COMMITTEE OF THE WHOLE MAY 21, 2002

**SITE DEVELOPMENT FILE DA.01.094
791296 ONTARIO LIMITED**

THAT Site Development Application DA.01.094 (791296 Ontario Limited) BE APPROVED, with revisions, subject to the following:

ATTACHMENT '2'
 SITE PLAN/LANDSCAPE PLAN
 RED-LINE REVISED

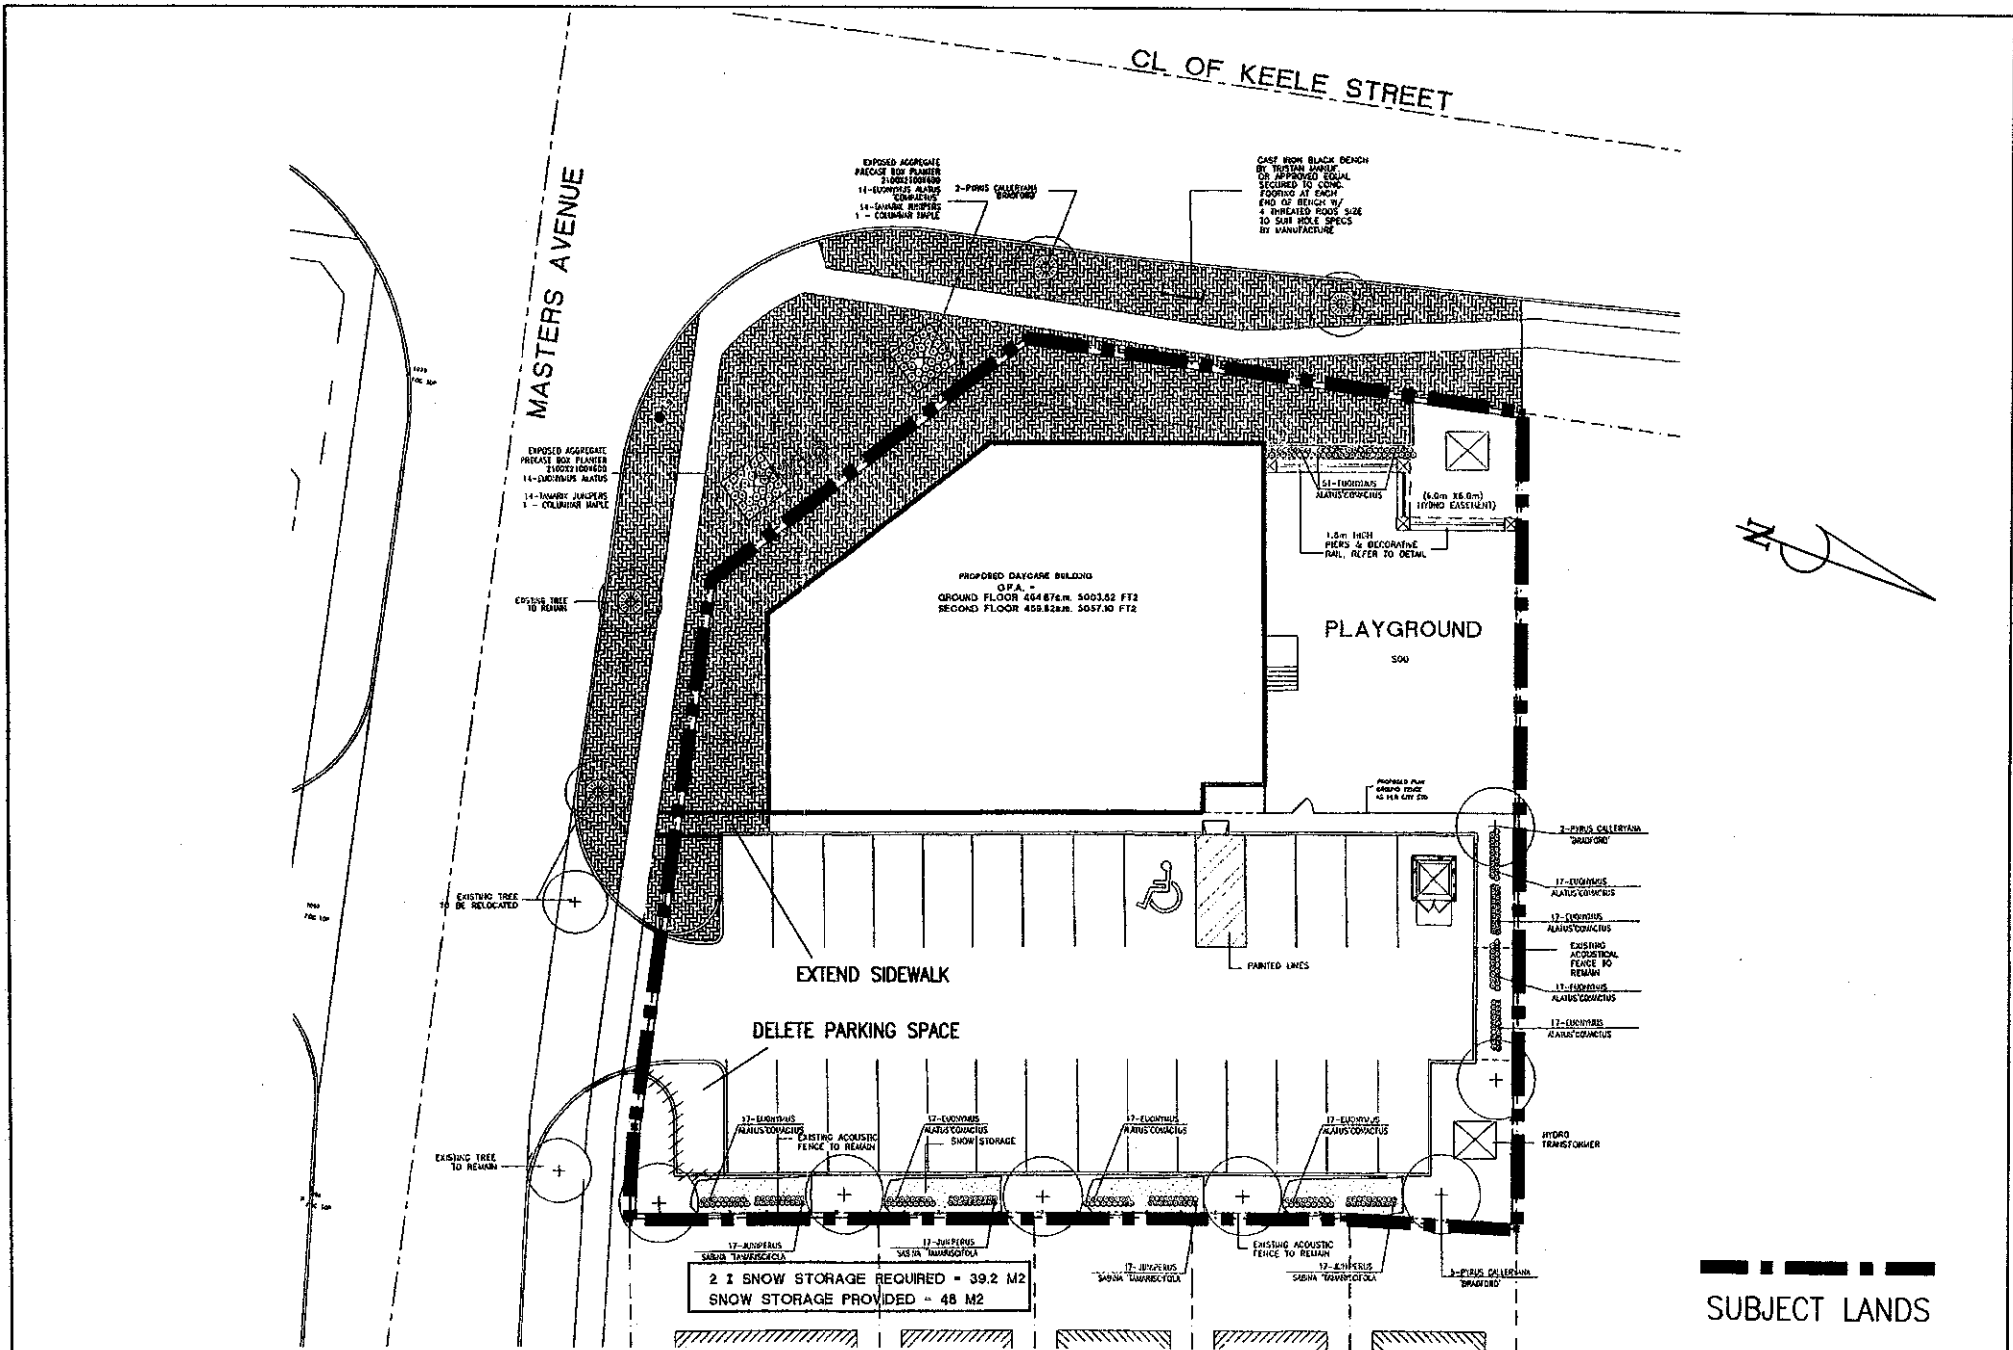
- ii) the landscape plan being revised to provide the street furniture lighting, street paving and other landscape details as per the Maple Streetscape Guidelines and the Maple Streetscape Master Plan Study, and a sidewalk connecting to Masters Avenue;

- iii) the parking space closest to Masters Avenue being deleted and the curbs reconfigured at the driveway entrance to provide functional parking spaces; and

- iv) that the curbs along Keele Street be reconfigured to incorporate lay-by parking as per the Maple Streetscape Plan, to the satisfaction of the Region of York.

The 2 parking spaces adjacent to the driveway do not meet the by-law requirement for 6m depth and may conflict with vehicular movement. Reconfiguring the driveway curbs, in accordance with City standards, may achieve for a depth of 6m for the westerly space, and the easterly space should be removed.

The fencing facing Keele Street and Masters Avenue features a variegated stone masonry wall topped off with decorative railing, with flanking masonry piers. The plans need to be modified to show the masonry in a brick similar to that used at the southeast corner of Keele Street and Major Mackenzie Drive.

**ATTACHMENT '3'
ELEVATIONS**

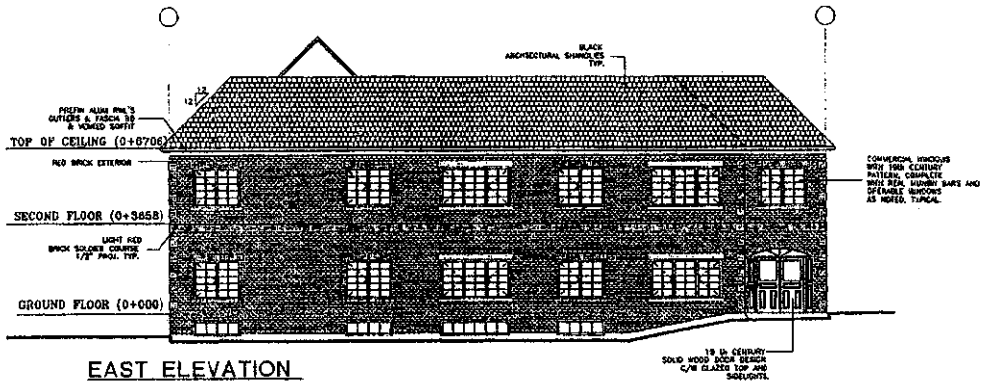
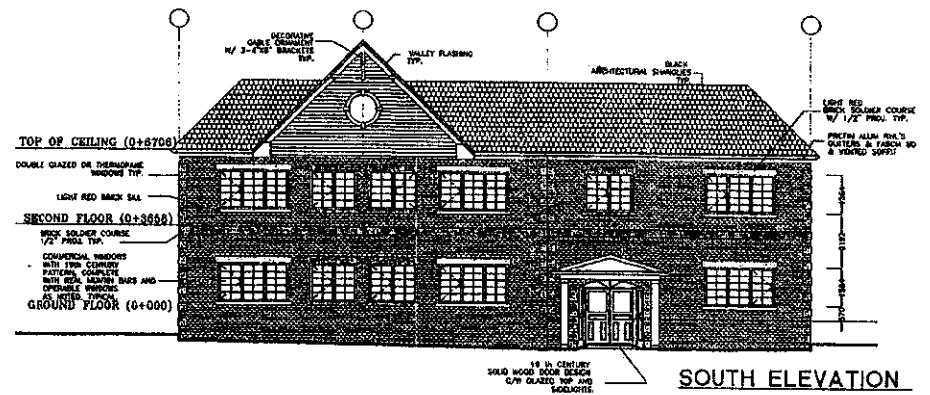
- a) That the site plan be revised to address the matters set out in the April 30, 2002 memorandum of the Director of Urban Design, including:
 - i) the elevations being revised to provide:

- a ground floor/grade relationship
 - the projections of the porticoes/canopies shown on the site plan
 - an increase in the roof pitches for the porticoes/canopies and gables

- the use of gable walls and roofs that slightly project from the principle building face
 - single/double hung sash windows
 - complete elevations for the refuse enclosure;

The building is a 2-storey building, with raised basements at the streetline. The ground floor of the building needs to be lowered so that the ground floor of the building relates directly to grade in accordance with the Maple Streetscape Guidelines. The building material is to consist primarily of red brick, with a light red brick soldier course separating the ground and second floors, and brick quoining at the corners. The roof will be covered with black architectural shingles.

The proposal provides for casement windows with muntin bars, which features a light-red brick lintel and sill. It is recommended that the windows be single/double hung sash, rather than casement, to harmonize with the historic/architectural character of the Maple Core Area. Further, the height of the ground floor windows should be increased, reflecting a more institutional/commercial character and providing more prominence to the ground floor of the building.

The proposal is providing an exterior refuse enclosure at the north end of the parking area. The details provided for the refuse enclosure indicate that it will have a red brick facade and black asphalt shingles to match the proposed building. As the refuse enclosure rear and sides are exposed to the residential area, playground area and parking area, the elevations for the entire structure are required.

MASTERS AVE. ELEVATION

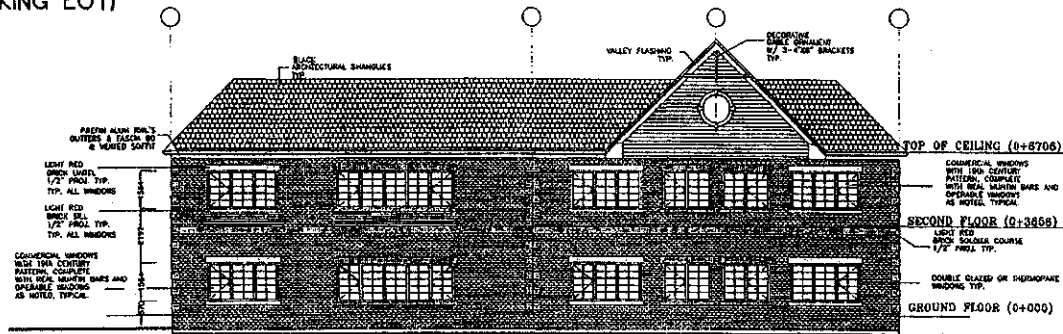
The west and south facades, facing Keele Street and Masters Avenue respectively, need to incorporate further architectural interest to enhance the building's street presence. It is recommended that the gable walls and roofs slightly project from the principle building face to improve massing, articulation and rhythm. In addition, the gable roof should have a pitch from 1:2 to 1:2.5 to achieve an appropriate proportion.

A solid wood double-door entrance featuring a portico/pilaster and sidelights is on the south elevation and a solid wood single door entrance with a portico/pilaster treatment and sidelights. The amount to which these elements project beyond the building face should be confirmed on the site plan. Also, the roof pitch associated with these elements should be increased to 1:2 to 1:2.5.
